**re:     Geotechnical Review of Grading Plans**  
**Proposed Commercial Development**  
1015 & 1045 Dairy Drive – Ottawa, Ontario

**file:   PG6498-MEMO.03**

## **Grading Plan Review**

**FIGURE 1**

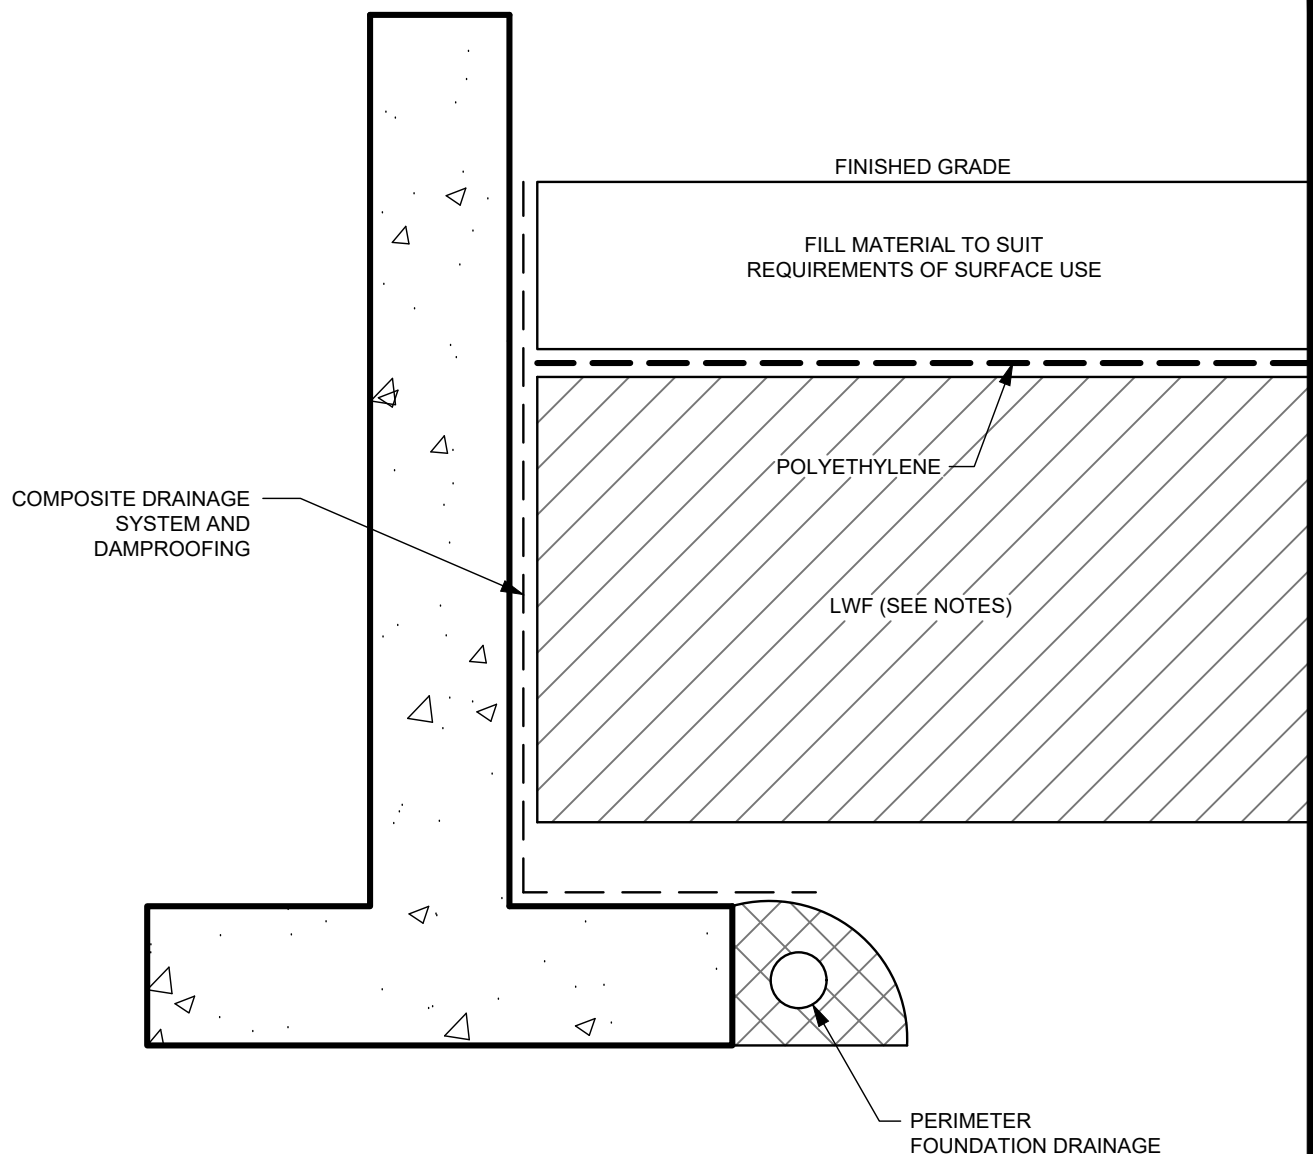
The attached Drawing PG6498-7 depicts the locations and the thickness of the lightweight fill (LWF) required based on our grading plan review, and the attached Figure 1 provides a general detail for LWF placement. The EPS blocks should be placed on a level, well-prepared subgrade, with a geotextile separation layer to prevent soil intrusion and to promote drainage. The EPS blocks should be installed in a staggered, interlocking pattern and should be protected with a granular cover layer. The LWF placement should be conducted under the supervision of a geotechnical engineer.

1. USE EPS12 BELOW FRONT PORCH AND LANDSCAPED AREAS
2. USE EPS19 BELOW PAVED AREAS
3. MINIMUM GRANULAR THICKNESS OVER LWF SHOULD BE AS FOLLOWS:

PAVED AREAS	450mm OF OPSS GRANULAR A
LANDSCAPED	500mm OF APPROVED BACKFILL SOIL

4. PLACEMENT OF LWF SHOULD BE ON A LEVELED SURFACE (SAND CAN BE USED TO PROVIDE AN ADEQUATE LEVELLING SURFACE).
